01. Outdoor Pool Plan as proposed

Client Bishopstrow House Ltd
Project Bishopstrow House
Title Outdoor Pool - Plan as proposed

Dwg No. 1501 317 C
Scale 1:100 @ A1
Date July 2025

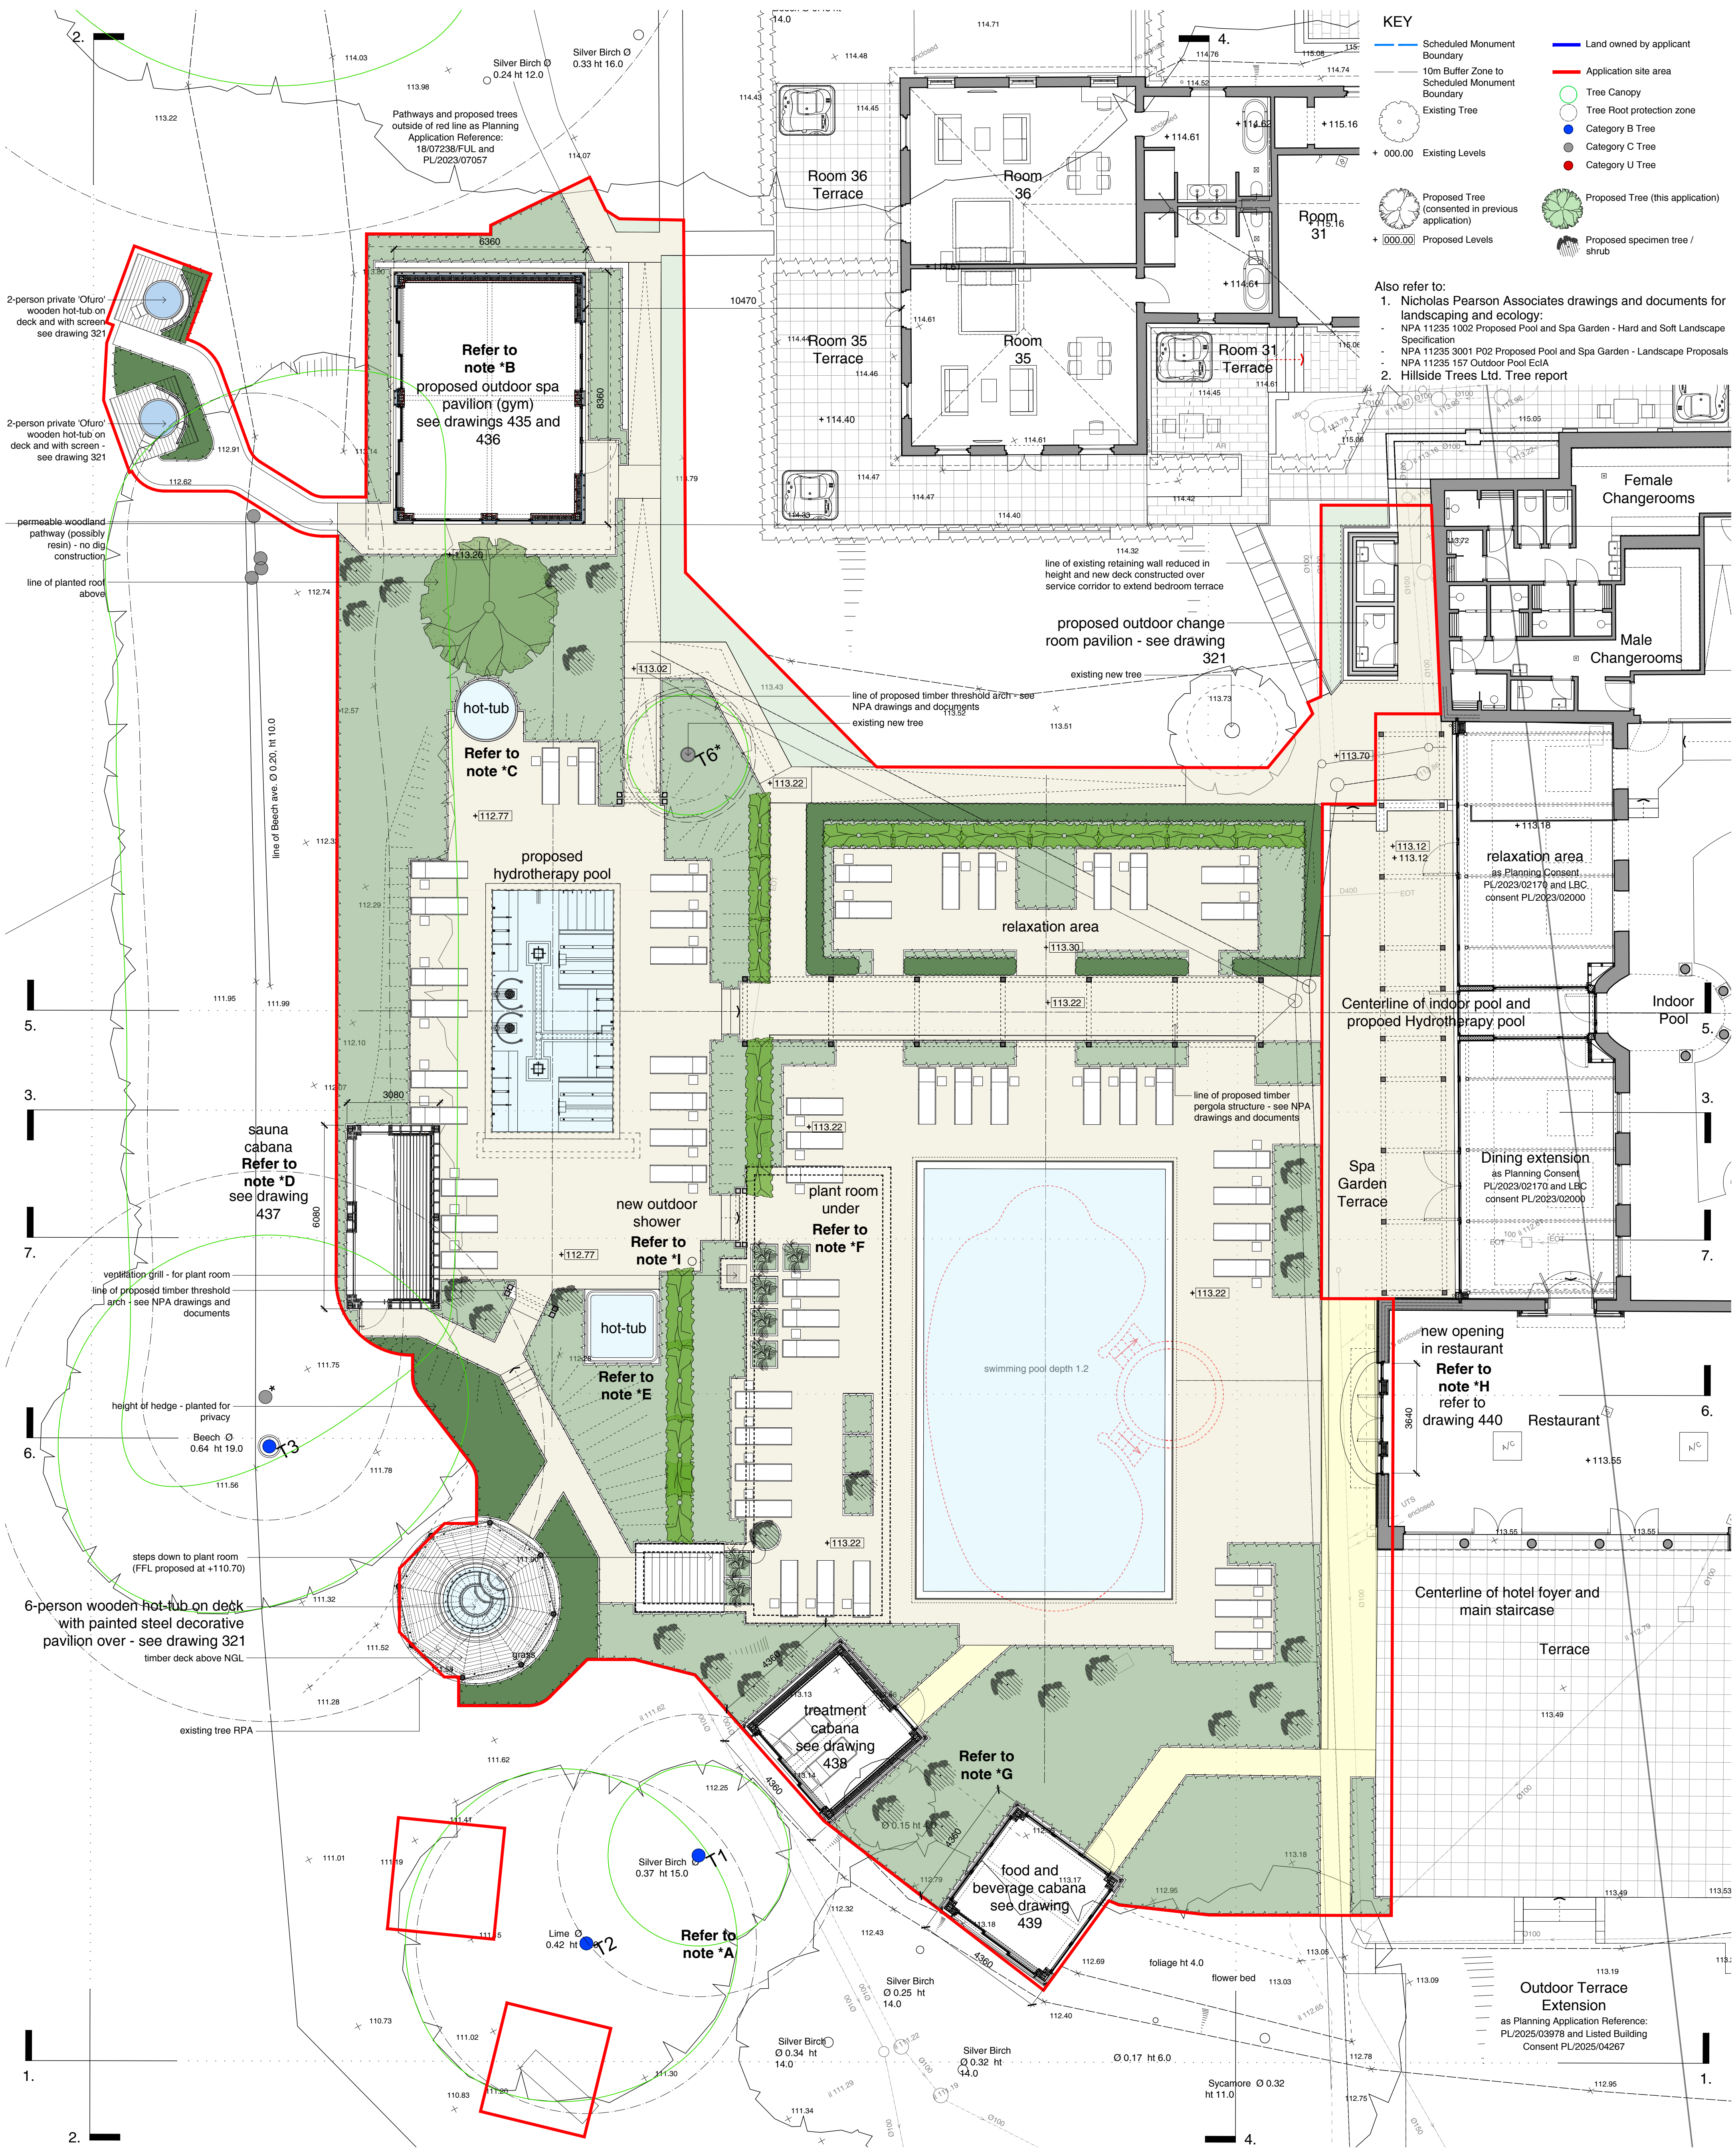
- * VAR Changes highlighted in Revision C from previous 2025 application (PL/2025/06091):
- A. the four dining domes are proposed as demolished
 - B. The Spa Pavilion structure has been simplified - refer to revised drawing 435 and 436.
 - C. The proposed plunge pool is now a hot tub.
 - D. a new cabana structure (sauna) is proposed on the edge of the Hydrotherapy pool terrace - see drawing 437.
 - E. A new hot tub is proposed on the edge of the Hydrotherapy pool terrace
 - F. the footprint of the proposed submerged plant room has been increased to accommodate the required plant
 - G. two of the dining domes are proposed as replaced with new cabana structures - see drawings 438 and 439
 - H. the proposed outdoor bar has been removed. Opening in restaurant wall has been adjusted - see drawing 440
 - I. new outdoor shower proposed on hydrotherapy pool terrace
